VALUE ENGINEERING REPORT

SR 83 Connector
Project No. STP00-0000-00(411), PI No 0000411
City of Monroe
Walton County

July 14, 2011

AMEC E&I, Inc.
3200 Town Point Drive NW, Suite 100
Kennesaw, GA 30144

Sheet 3 of 6

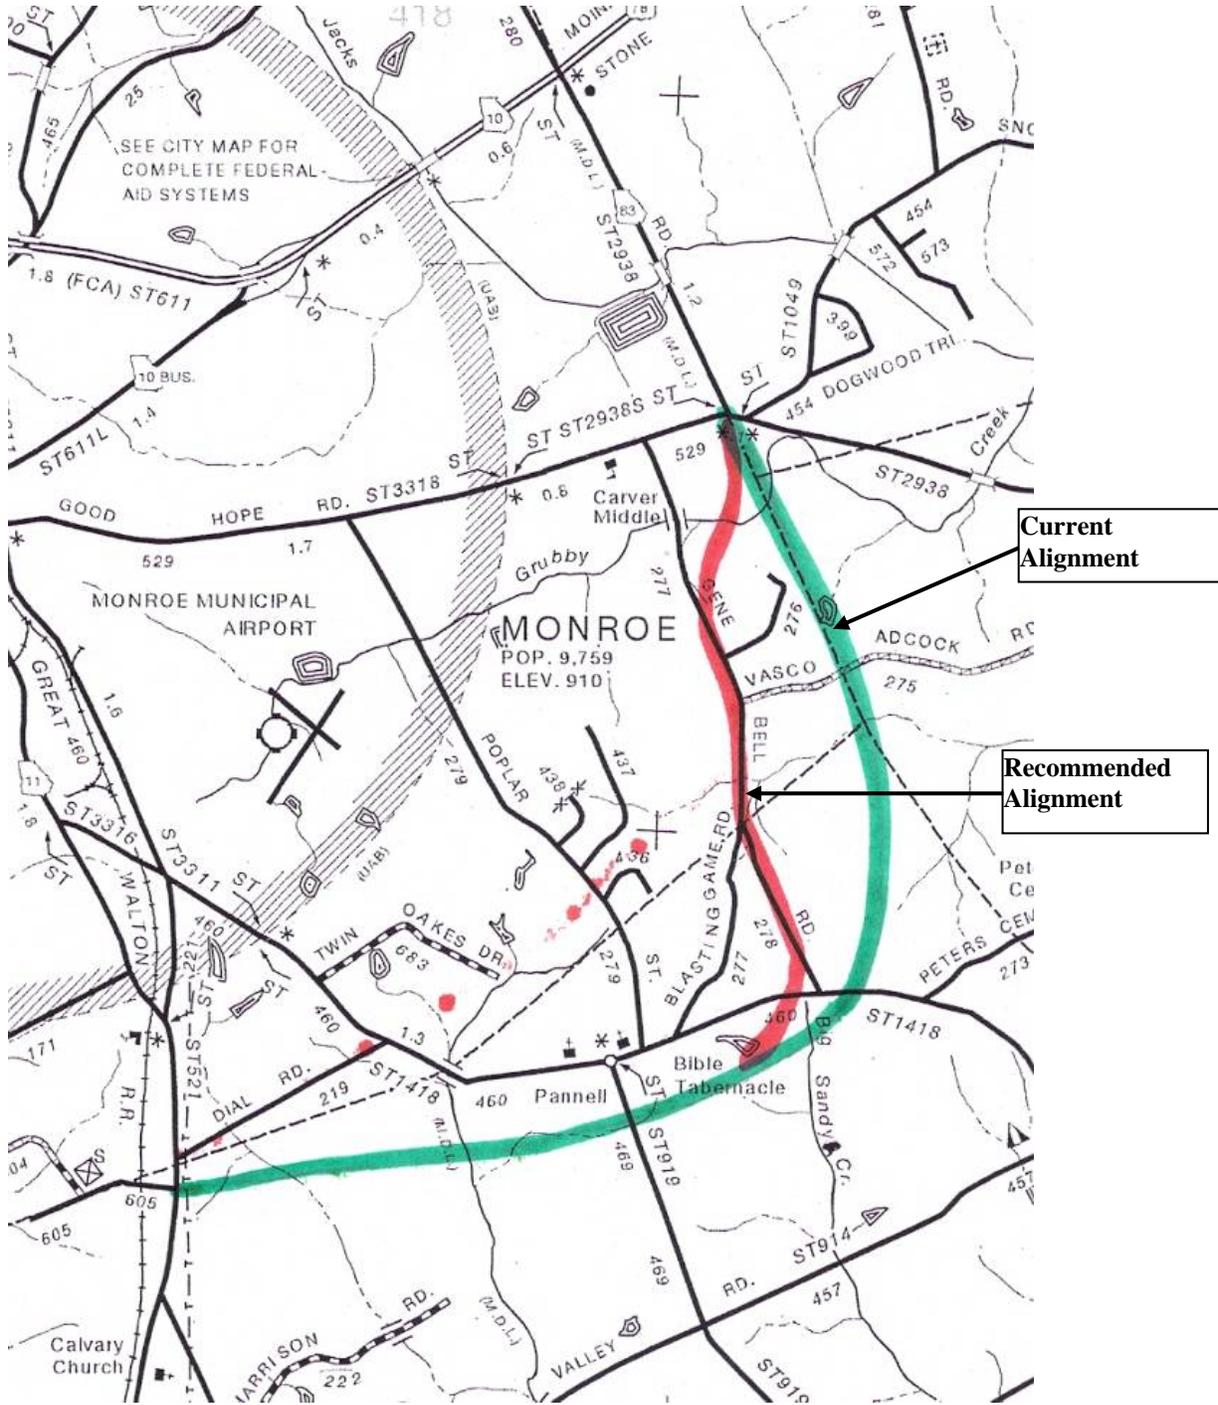
This recommendation would revise the alignment of the 2-lane connector route. The revised alignment would follow the original SR 83 Connector alignment for the southern portion (Station 5+00 to Station 100+00), curve left and connect to Gene Bell Road just east of the J. N. Conner property, follow Gene Bell Road to approximately 1,000 feet north of Bell Trailer Park Road, and turn right through the Harriette Little property connecting back to SR 83 north of Good Hope Road.

Using the existing roadway network for a portion of the SR 83 Connector will reduce R/W costs, shorten the project approximately 1,800 feet, reduce wetland / stream impacts, and reduce Environmental Mitigation cost. This revised alignment meets the project goals and objectives of removing trucks from the downtown area. The original alignment has a b/c ratio of 7.99 providing room to modify the alignment and still provide significant time reduction. This ratio should be recalculated for the revised alignment to determine whether an acceptable time reduction is still achieved. It is recommended that both a 55 MPH and 45 MPH design speed be considered in the b/c ratio recalculation.

Revise SR 83 Connector Alignment to use Gene Bell Road

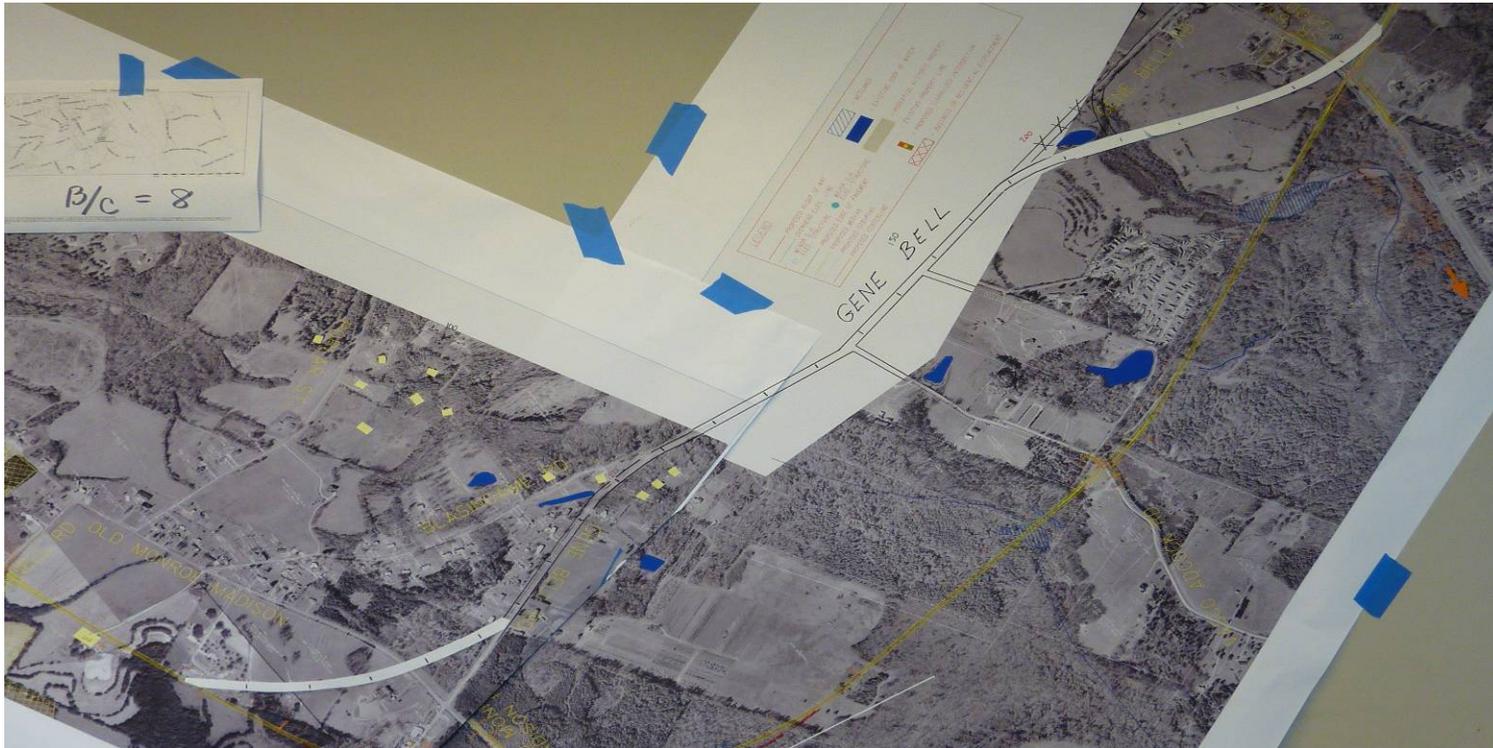
The new alignment along Gene Bell Road goes through a small residential area. A review of this area on Google Maps indicates the abutting homes appear to be offset far enough to avoid any additional displacements and facilitate the necessary roadway and R/W improvements. Since the overall project will be slightly shorter, the VE team assumed that all project costs and impacts will be proportionately reduced including drainage, paving, grading, clearing, erosion control, wetlands effects and mitigation.

Idea No.: A-3.1
Client: City of Monroe / GDOT
Sheet 3 of 5

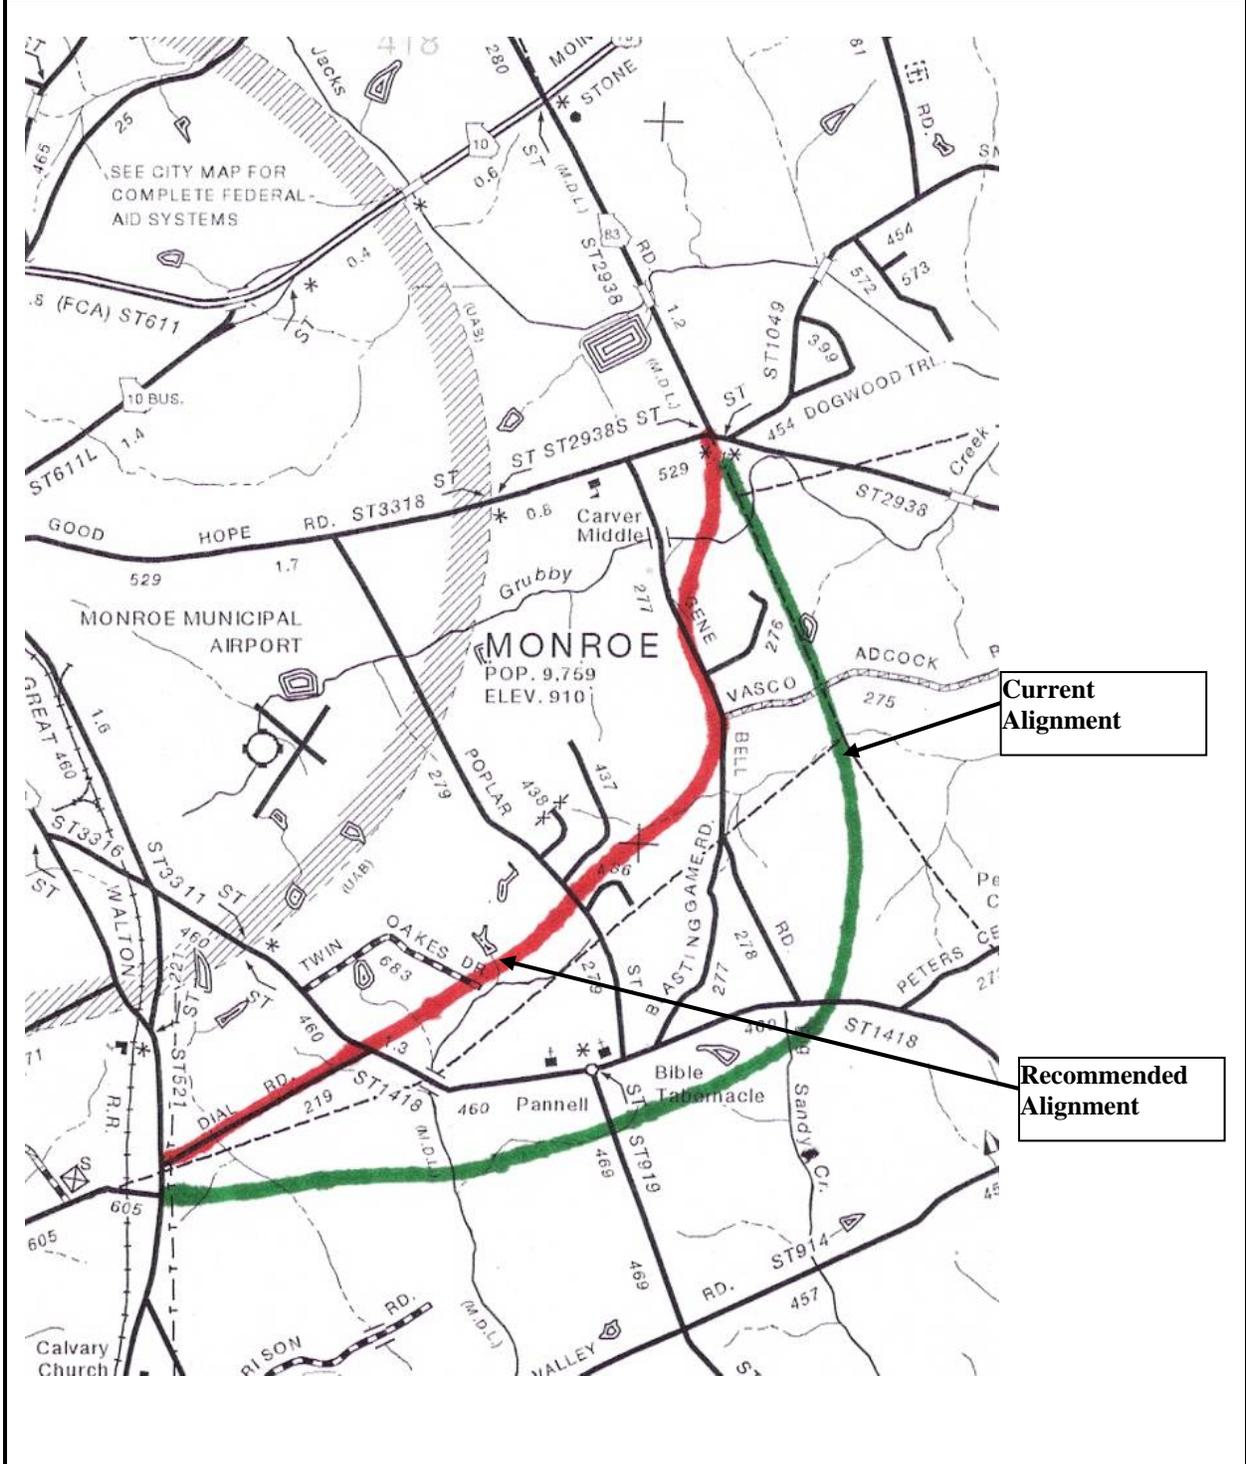
This recommendation would revise the alignment of the 2-lane connector route. The revised alignment would follow the existing Dial Road and extend along the existing property lines, past Poplar Street and connect to Gene Bell Road just north of Blasingame Road and follow Gene Bell Road to Good Hope Road and on to SR 83.

The new alignment along Gene Bell Road goes through a small residential area. A review of this area on Google Maps indicates the abutting homes appear to be offset far enough to avoid any additional displacements and facilitate the necessary roadway and R/W improvements. Since the overall project will be shorter by about 4,400 ft the VE team assumed that all project costs and impacts will be proportionately reduced including drainage, paving, grading, clearing, erosion control, wetlands effects and mitigation. We also assumed the existing roads would be completely reconstructed to match the original proposed typical section. Additional assumed traffic control costs and Blasingame Road intersection improvement costs have been added to this option.

Sheet 2 of 4

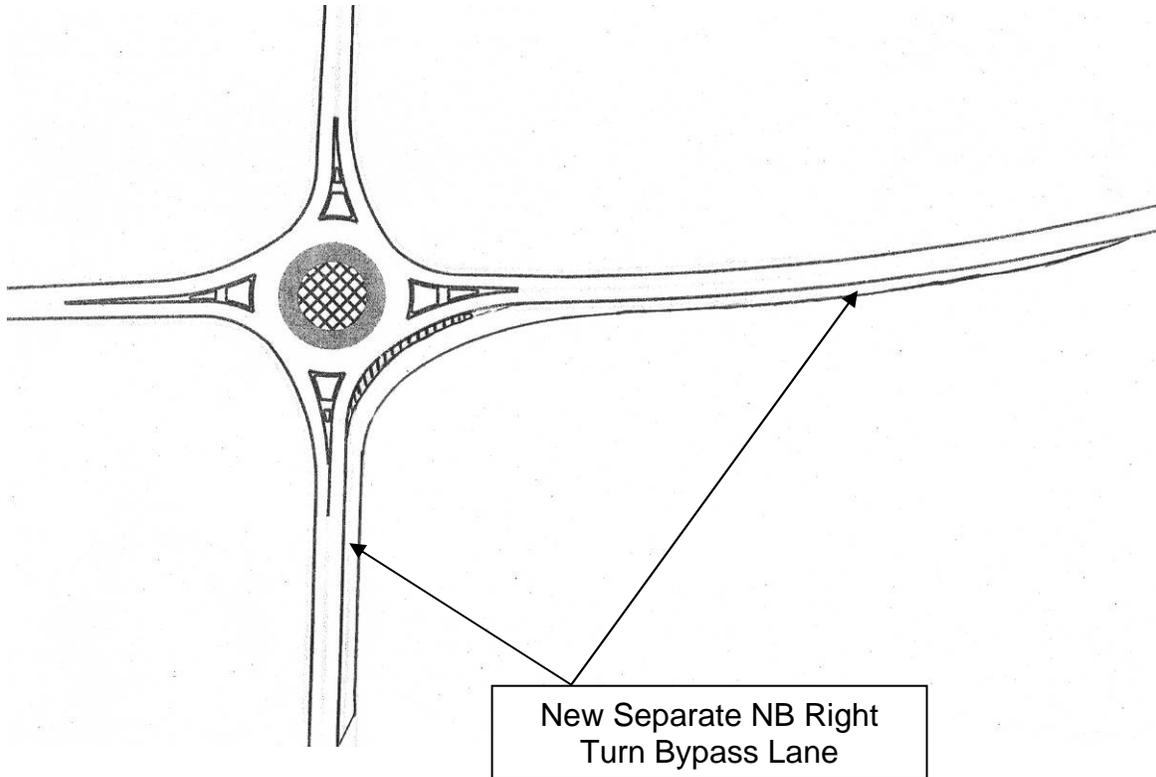
This recommendation would revise the proposed roundabout at the SR 11 / Lower Industrial Park Road / SR 83 Connector intersection to provide a separate NB SR 11 to NB SR 83 Connector right turn bypass lane in the southeast quadrant.

The percentage of trucks on the projects is high (15 %). The addition of a right turn bypass lane in the southeast quadrant of the intersection will improve the operation of the roundabout and reduce conflicts with truck going northbound on the bypass. This concept adds value to the project and results in a slight cost increase.

Sheet 2 of 4

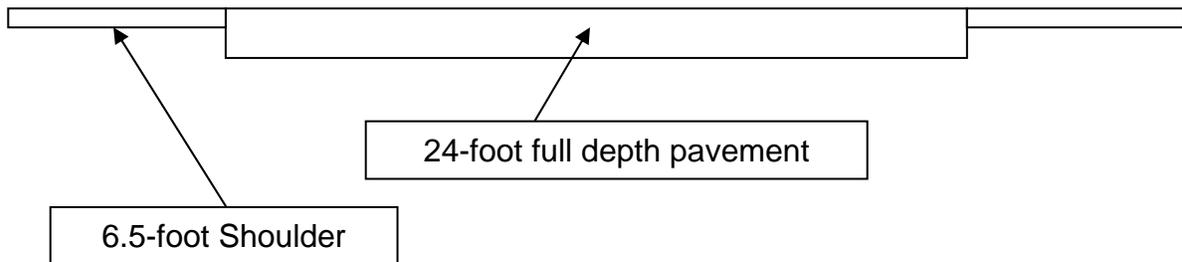
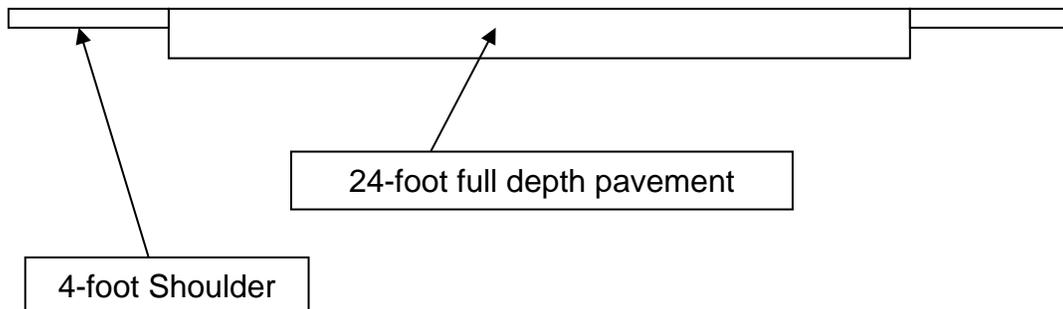
This recommendation would reduce the paved shoulder width from 6.5 feet to 4 feet. This concept provides the same function as the original design. The total shoulder width would remain at 10 feet.

Sheet 2 of 4

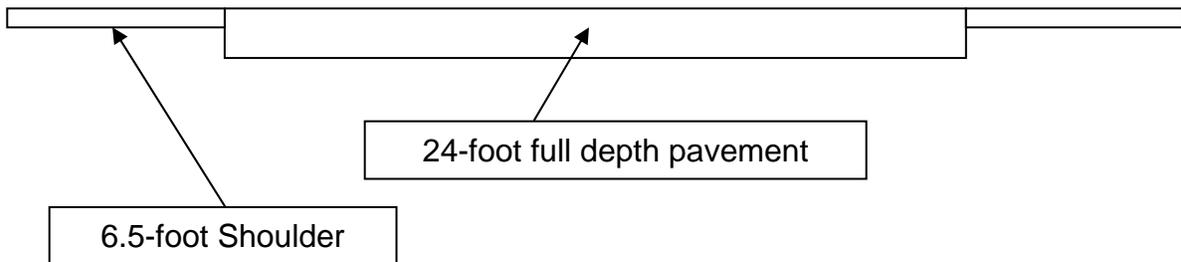
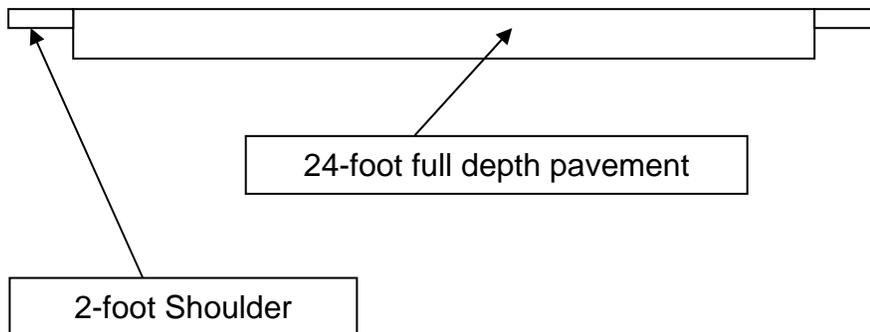
This recommendation would reduce the paved shoulder width from 6.5 feet to 2 feet. This concept provides the same function as the original design. The total shoulder width would remain at 10 feet.

Sheet 2 of 4

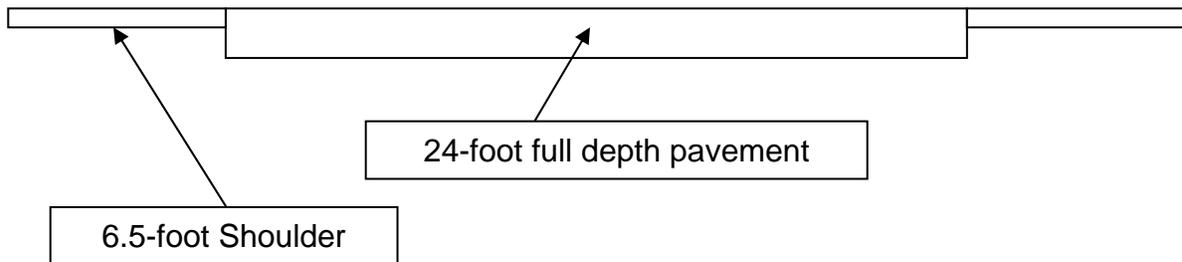
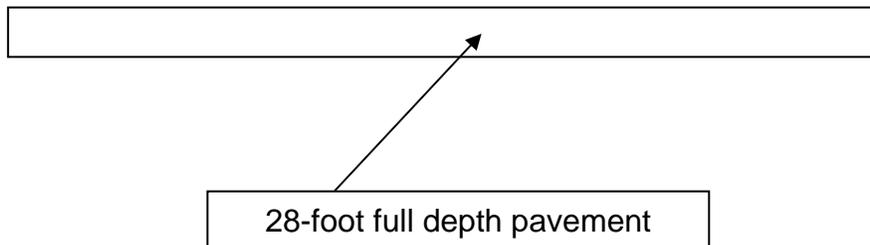
This recommendation revises the paved shoulder width from 6.5 feet to 2 feet and constructs the 2-foot shoulder the same thickness and the mainline roadway. This concept eliminates the standard joint along the edge of pavement and paved shoulder by constructing a uniform full-depth 28-foot roadway section. Removing this joint eliminates future paved shoulder maintenance. This concept provides the same function as the original design. The total shoulder width would remain at 10 feet.

Sheet 2 of 4

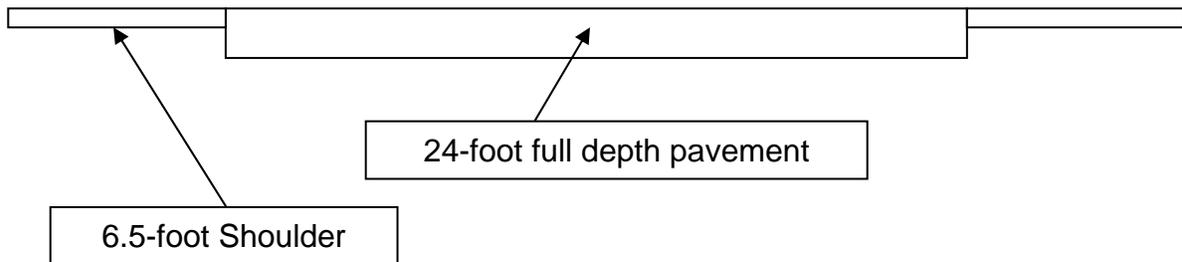
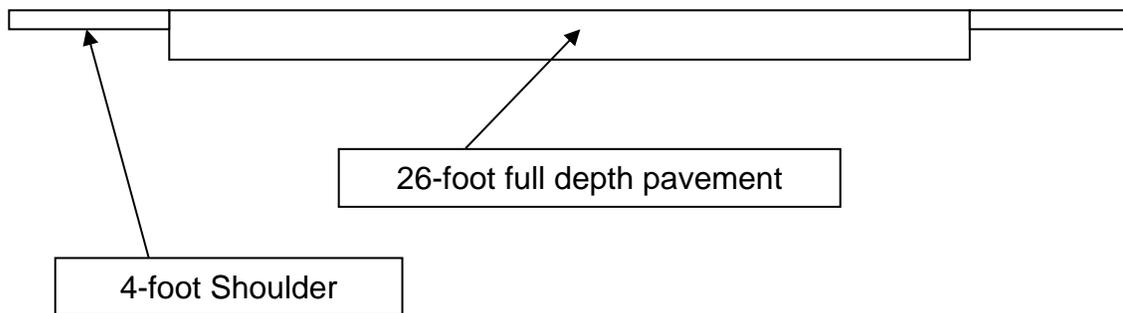
This recommendation would widen the roadway full-depth template by 1-foot on each side (lanes would be striped at 12 feet) and provide an additional 4 feet of paved shoulders per side.

Revise the skew angle at the SR 83 Connector / Old Monroe Madison Road Intersection

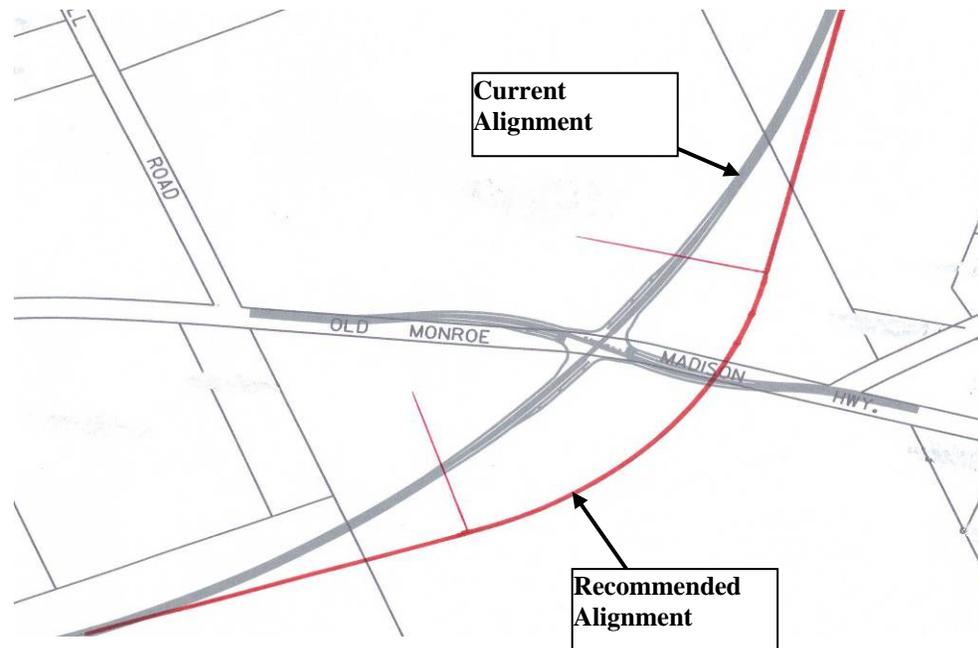
Reducing the SR 83 Connector curve radius from 1,330 feet to the minimum allowable curve radius of 1,060 feet and extending the SR 83 Connector tangents will improve the skew angle of the intersection to about 80 degrees and eliminate the need for a design exception or variance. Improving the intersection skew angle will also shorten the amount of reconstruction and realignment required on Old Monroe Madison.

Revise Horizontal Alignment (Station 62 to Station 100) to Avoid Residential Take

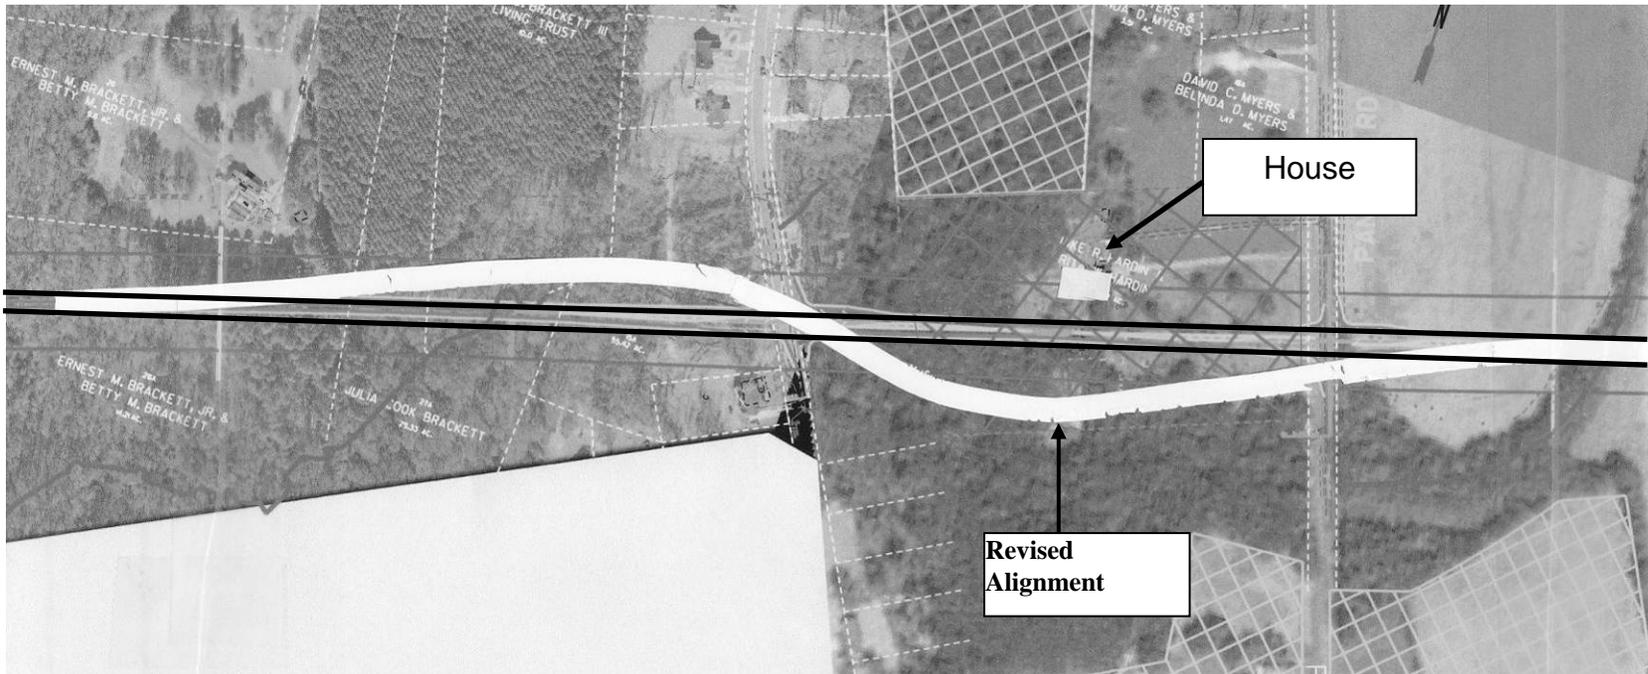
This recommendation would revise the original tangent alignment and avoid the displacement west of the Pannell Road intersection. The revised alignment uses a series of minimum radius (55 MPH) curves to shift the alignment between Station 62 and Station 100 and avoid the need to take the house. The proposed realignment shifts the roadway to the north (Station 62 – 79) before shifting to the south (crossing at Brush Creek Drive) to avoid the house and connecting back to the original alignment near Station 100.

The purpose of the project is to provide a new roadway location for trucks to bypass around the City of Monroe. This concept would revise the proposed bypass alignment between Station 62 and Station 100 by inserting a minimum radius reverse curve through this area to avoid the original R/W displacement. This concept meets the original purpose of the project without causing any displacements.
